Mount Carmel
MP site 12/22

From: Ali Zahedian [azahedian@msn.com]
Sent: Wednesday, May 11, 2011 4:54 PM
To: Fothergill, Anne
Subject: Mt. Carmel

From: Fothergill, Anne
Sent: Wednesday, May 11, 2011 2:36 PM
Subject: 5/11 staff item #3

I.F - 21515 May 11 staff item
Dickerson Road, Di.. Mount Carmel...

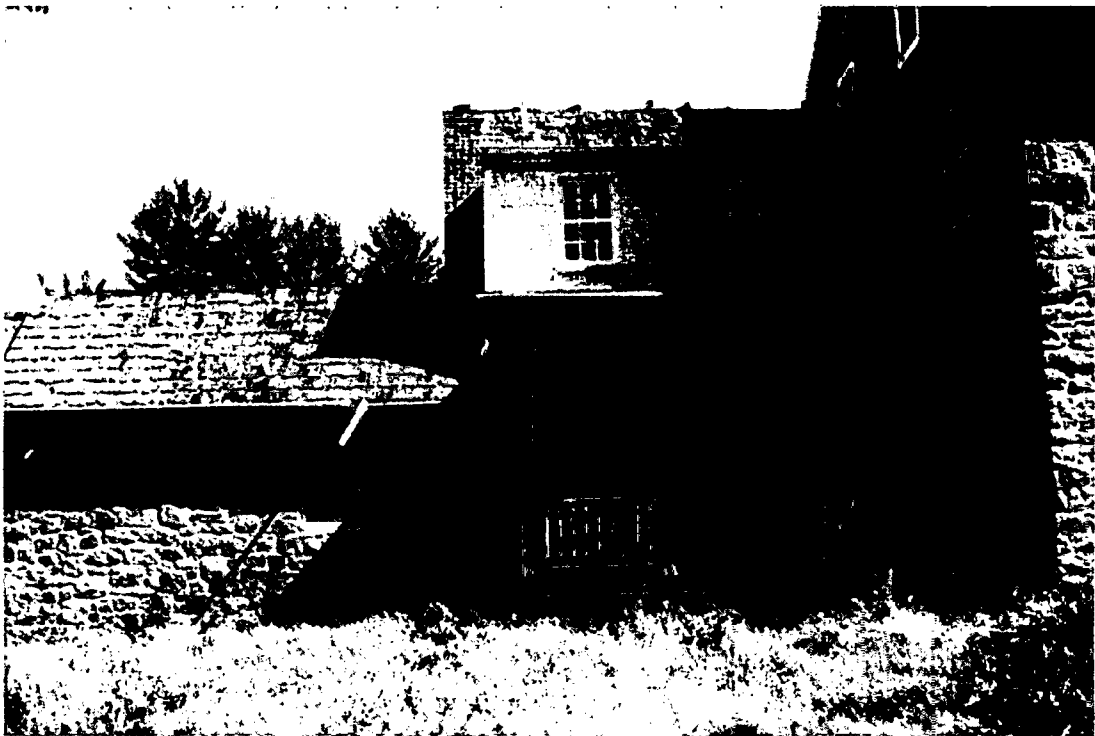
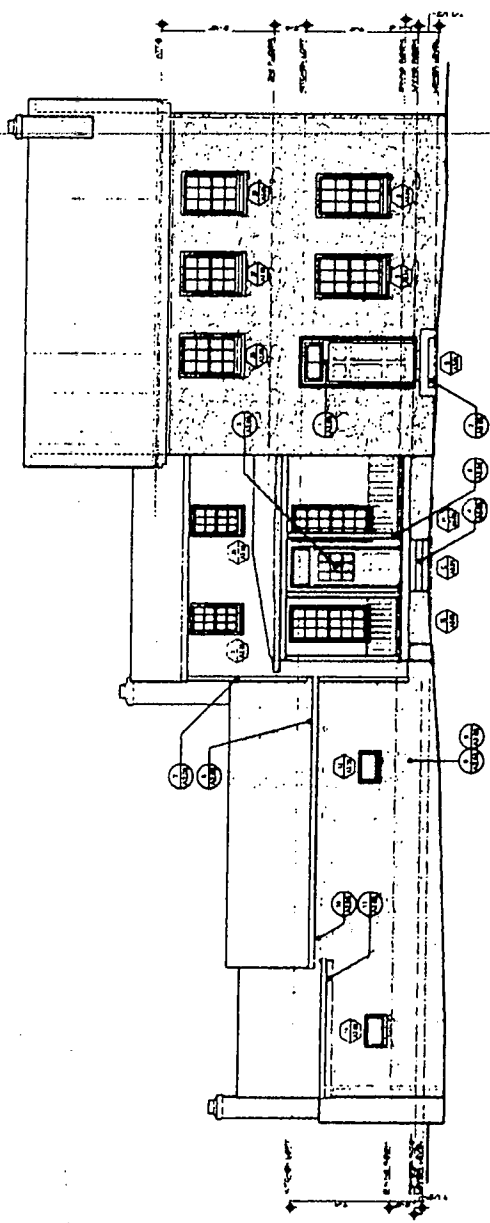
As mentioned earlier today do to ant and termite infestation it appears that we must remove all existing siding (Between 200-300 square feet) fix and replace the plywood and install new siding. The existing siding is approximately 1" thick and 12" wide, we are proposing to use SMARTSIDE by LP Building products This has the look of cedar and we can get this product 12" wide which matches the existing siding.

We also would like to use the same siding on the garage.

The applicants are currently working on the rehabilitation of the house and have found extensive termite damage and rot behind the cedar siding on the small frame section in the middle of the house (see photos). They are proposing to replace the existing wood siding with 1" thick and 12" wide Louisiana Purchase SmartSide siding that they state will look just like cedar. In the attachment you will see information about the material from the company's web site. The applicant intends to provide a material sample before tonight's meeting as well as a letter describing in more detail the conditions and the need for this material.

The 2nd part of this staff item is for the new garage that was approved to be constructed behind the house. The applicants are proposing to use this same siding material instead of wood siding on the new garage.

yes → garage
no → house

must be in-kind replacement
wood to match

100 SITE PLAN
 SCALE: 1/8" = 1'-0"

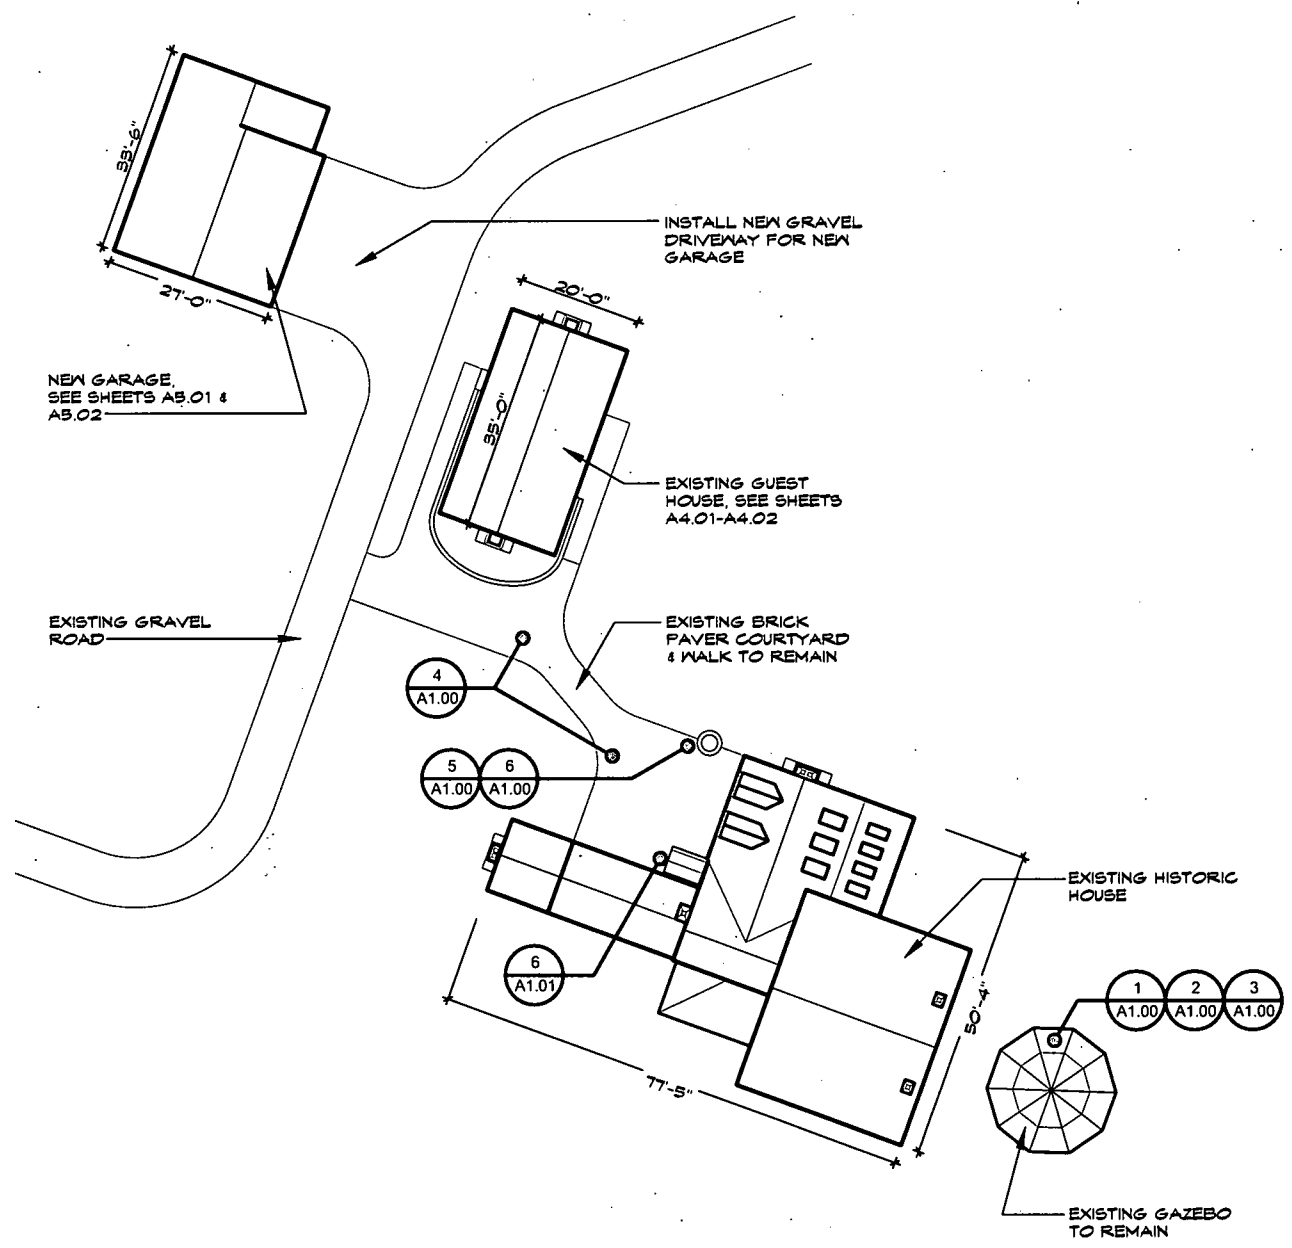
see revised site plan
 in circle 11
